## City of Phoenix

### ADDENDUM A

#### **Staff Report: Z-16-18-5**

<b>Maryvale <a href="#">Village Planning Committee</a> Meeting Date:</b>	May 9, 2018
<b><a href="#">Planning Commission</a> Hearing Date:</b>	June 7, 2018
<b>Request From:</b>	<a href="#">PUD PCD</a> (131.27 Acres)
<b>Request To:</b>	<a href="#">R1-6</a> (131.27 Acres)
<b>Proposed Use:</b>	Single-Family Residential
<b>Location:</b>	Northeast corner of Loop 101/Agua Fria Freeway and Indian School Road
<b>Owner/Applicant:</b>	Algodón AG Revocable Land Trust
<b>Representative:</b>	Stephen W. Anderson, Gammage & Burnham, PLC
<b>Staff Recommendation:</b>	Approval, subject to stipulations

Circulation Plan

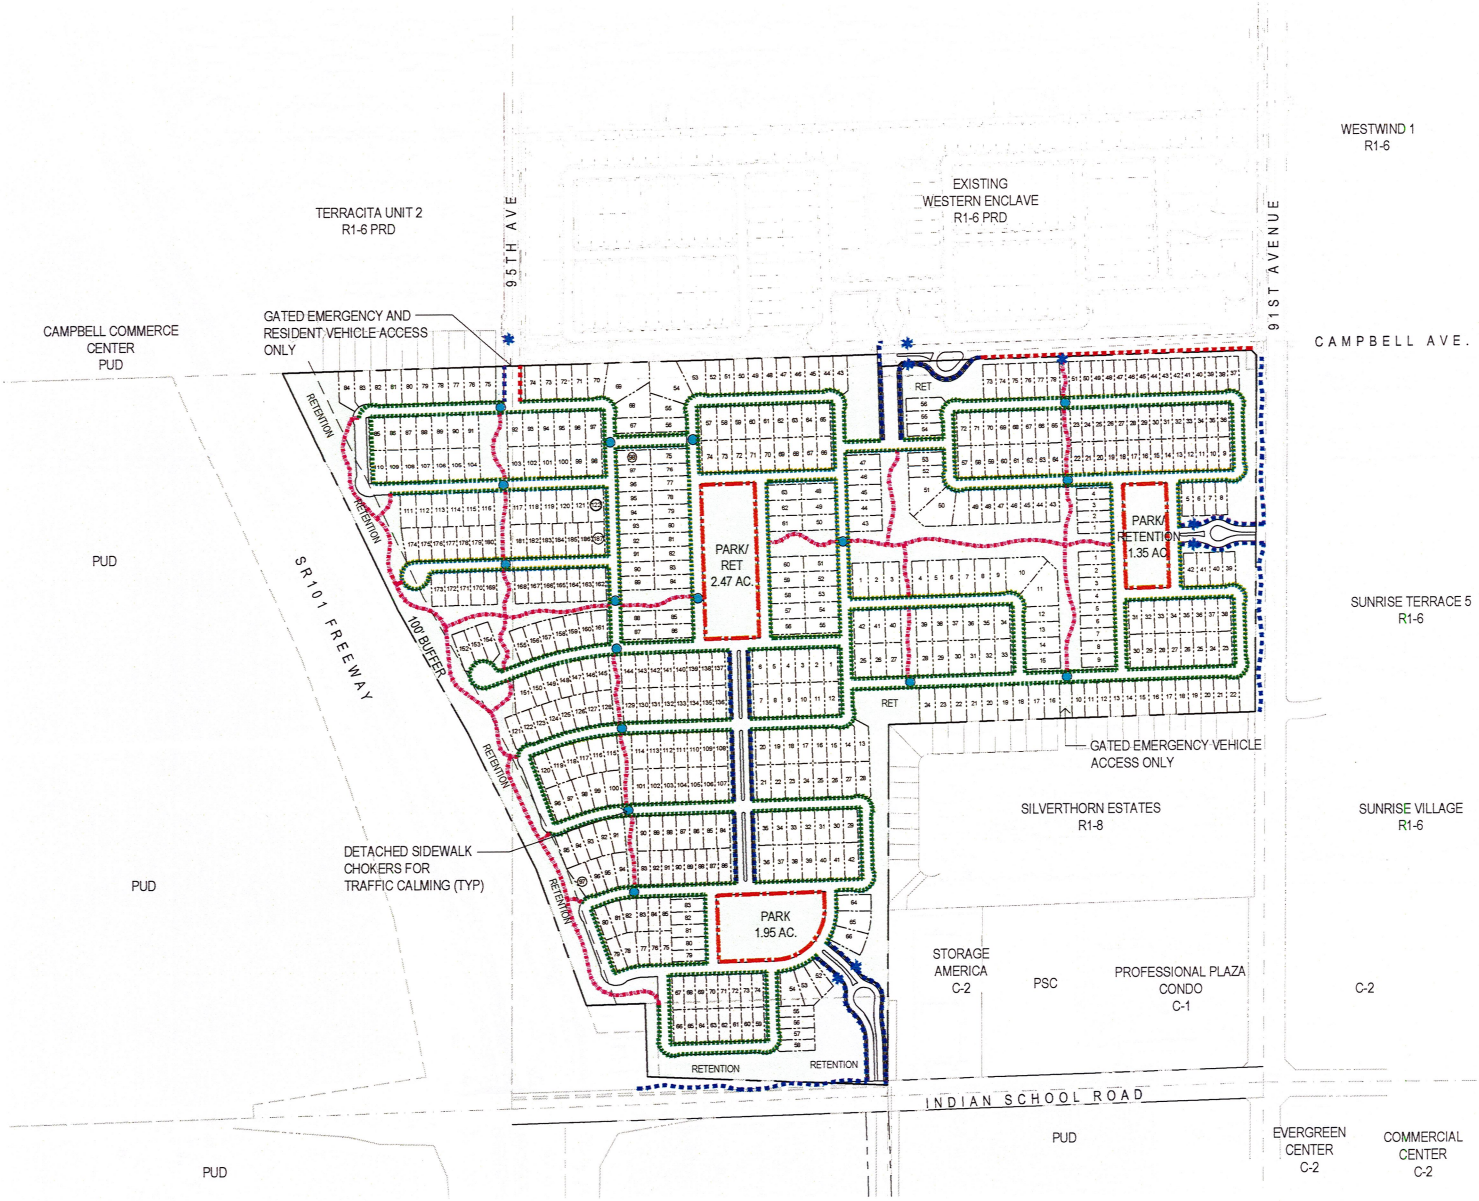
As a result of ongoing dialogue, and the applicant's submittal of a revised Circulation Plan, city staff and the applicant have come to an agreement to revise the following:

- Revise stipulation 2 to increase the minimum open space from 15% to 20%.
- Remove stipulation 4 which has been addressed through the depiction of a pedestrian pathway along the western boundary in the revised Circulation Plan.
- Modify stipulation 6 to stipulate general conformance to the quantity and location of circulation elements (sidewalks, trails, and traffic mitigation infrastructure) as depicted on the revised Circulation Plan.

THE DEVELOPMENT'S CIRCULATION ELEMENTS (SIDEWALKS, TRAILS, AND TRAFFIC MITIGATION INFRASTRUCTURE) SHALL BE IN GENERAL CONFORMANCE WITH THE CIRCULATION PLAN DATE STAMPED JUNE 4, 2018, AS APPROVED OR MODIFIED BY THE PLANNING AND DEVELOPMENT DEPARTMENT WITH SPECIFIC REGARD TO THE, SIZES, QUANTITIES AND LOCATIONS OF THE ELEMENTS AND THE INCLUSION OF THE FOLLOWING PROVISIONS.

- A. DETACHED SIDEWALKS SHALL INCLUDE A MINIMUM FIVE-FOOT-WIDE LANDSCAPED STRIP LOCATED BETWEEN THE SIDEWALK AND BACK OF CURB AND MINIMUM 2-INCH CALIPER SHADE TREES PLANTED A MINIMUM OF 20 FEET ON CENTER OR IN EQUIVALENT GROUPINGS ALONG BOTH SIDES OF THE SIDEWALK.
- B. EACH "DETACHED SIDEWALK CHOKER TRAFFIC CALMING" ELEMENT SHALL BE A MINIMUM LENGTH OF 60 FEET AND THE PLANNING AND DEVELOPMENT DEPARTMENT SHALL HAVE THE AUTHORITY TO REDUCE THE MINIMUM LENGTH TO ACCOMMODATE OTHER SITE CONSIDERATIONS UPON REQUEST.
